MIL-DTL-26521K
AMENDMENT 2
8 January 2003
SUPERSEDING
INTERIM AMENDMENT 1
18 July 2002

DETAIL SPECIFICATION

HOSE ASSEMBLY, NONMETALLIC, FUEL, COLLAPSIBLE, LOW TEMPERATURE
WITH NON-REUSABLE COUPLINGS

This amendment forms a part of MIL-DTL-26521K, dated 15 February 1999, and is approved for use by all Departments and Agencies of the Department of Defense.

FIGURE 3. Test fixture for cold flexibility evaluation."

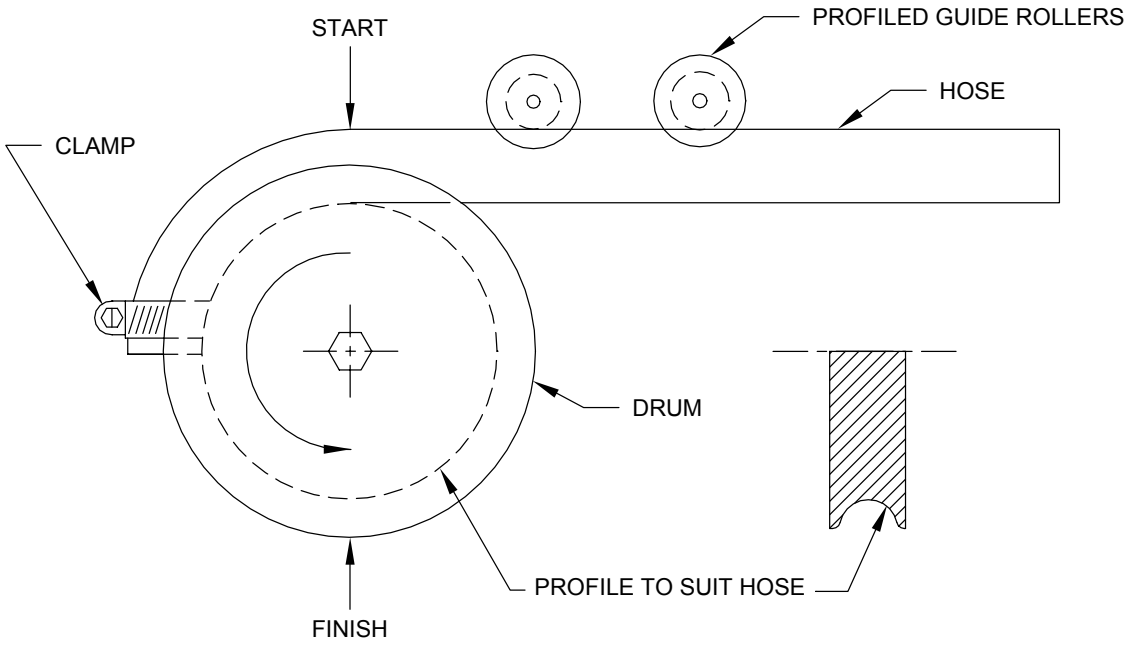
4.6.6 Delete and Substitute:

"4.6.6 Low temperature flexibility test. Test samples shall be preconditioned at -40ºF for at least 24 hours prior to testing. The flexibility tests shall be carried out with an empty length of hose, the length of which is calculated as follows:

b. Attach the hose to the test drum with the clamp as shown in figure 3.

c. Place the test drum and hose specimen in a cold box/bath to keep their temperature at -40ºF.

d. Rotate the test drum using a torque wrench with a dial indicator. The drum must be rotated 180º within 10 seconds.
